**ST JOSEPH THE WORKER SCHOOL WALKWAY EXPANSION
WAIVER FROM LAND DEVELOPMENT REQUEST 2024-701
ATTACHMENTS**

TO: PLANNING COMMISSION
FROM: GREGG ADAMS, PLANNER
**SUBJECT: ST JOSEPH THE WORKER SCHOOL WALKWAY EXPANSION
 WAIVER FROM LAND DEVELOPMENT REQUEST 2024-701
REQUEST FOR PLAN REVIEW**
DATE: MAY 3, 2024
**COPIES: BOARD OF COMMISSIONERS, T. PETRUCCI, D. MANHARDT,
 L. HARRIER, J. ZATOR, ESQ., J. ALDERFER, ESQ, A.
 TALLARIDA, S. PIDCOCK, APPLICANT, SUB. FILE 2024-701**

SUBJECT: South Whitehall Township
St. Joseph the Worker School
Sidewalk Expansion
Waiver from Land Development
Process Request #2024-701

DRAWN BY: JB DATE: 3-14-24 PROJECT NO: STJW 2301 DRAWING NO.: C-1.1
 APPROVED BY: JLO SCALE: 1" = 40' SHEET NO: 1 OF 1

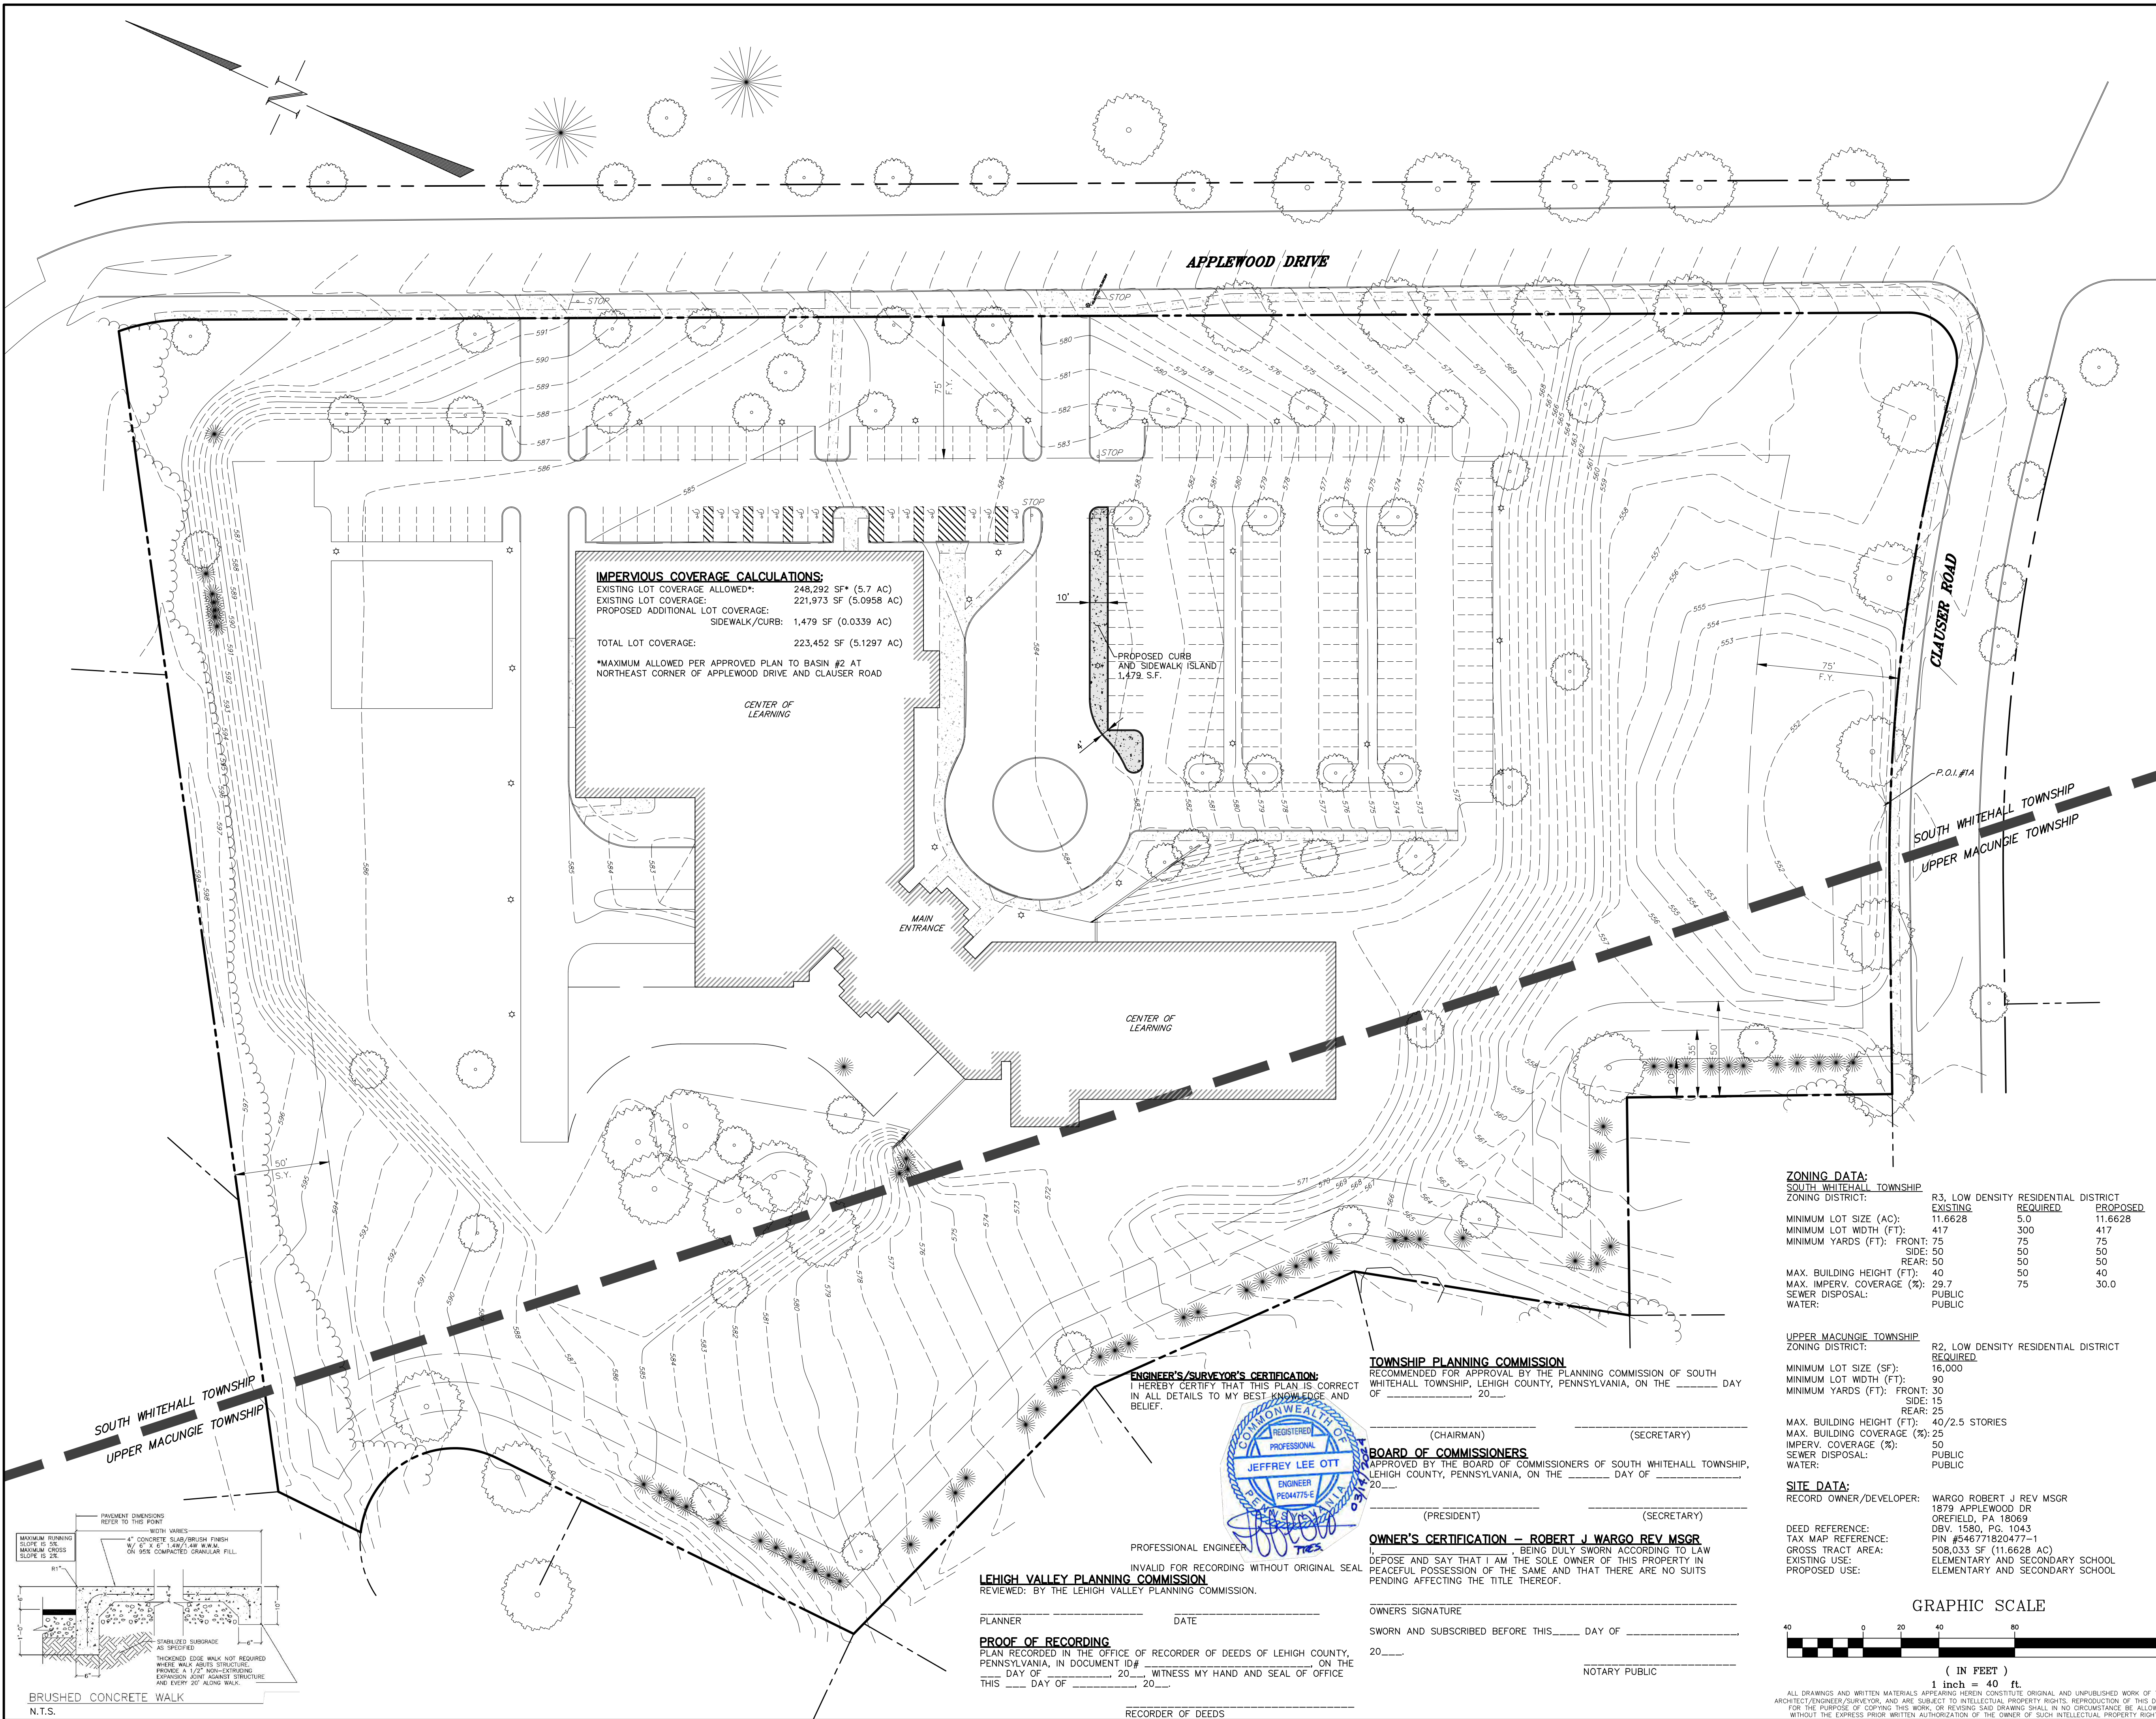
2. Confirm with the Township Staff the status of the existing waivers/deferrals/variances as they relate to the current proposal;
3. Check the required Minimum Lot Size (5 acres listed; 3 acres required), and the Minimum Lot Width (300 feet listed; 200 feet required) requirements contained in the Zoning Data Table, SALDO §312-12(b)(8)(F);

4. Provide the following information in accordance with SALDO §312-12(b):
 - a. Property and zoning district boundaries within 1,000 feet of the site on the Location Map, SALDO §312-12(b)(9)(A) and §312-12(b)(9)(D);

- b. The RR-3/R-3 zoning district boundary, SALDO §312-12(b)(13);
 - c. Tract boundary information, SALDO §312-12(b)(14);
 - d. Existing and proposed contour information within 400 feet of the site, SALDO §312-12(b)(15);

- e. A benchmark with vertical datum information, SALDO §312-12(b)(16);
 - f. Adjacent land owners, SALDO §312-12(b)(17);
 - g. Rock outcrops, stone fields, closed topographical depressions, and other features of ground subsidence, etc. or the absence of such features should be noted, SALDO §312-12(b)(18);

- h. Significant manmade features within 100 feet of the site (e.g., sewer mains, water mains, gas lines, fire hydrants, etc.), SALDO §312-12(b)(19);
 - i. Buildings within 100 feet of the site, SALDO §312-12(b)(20);

- j. Locations and widths of all sidewalk, trails, driveways, streets, easements, and right-of-way within 400 feet of the tract, SALDO §312-12(b)(21);

- k. Soils types and limits, SALDO §312-12(b)(22); and
 - l. Reference monuments, SALDO §312-12(b)(27).
- 5. Matters pertaining to the design of public water and sanitary sewer services should be directed to the Township Department of Public Works. We have not reviewed these designs;
- 6. Address any concerns of the Public Safety Commission to their satisfaction; and
- 7. Provide Certifications/Acknowledgements/Statements in accordance with SALDO §312-48(e)(2). The Planning Commission, Board of Commissioners, and Proof of Recording signature blocks are not necessary and may be removed. Upon submission of plans for recording, all Statements and Certifications shall be signed and sealed/notarized as applicable. Also, provide Applicant's Statements in accordance with SALDO §312-12(b)(6).
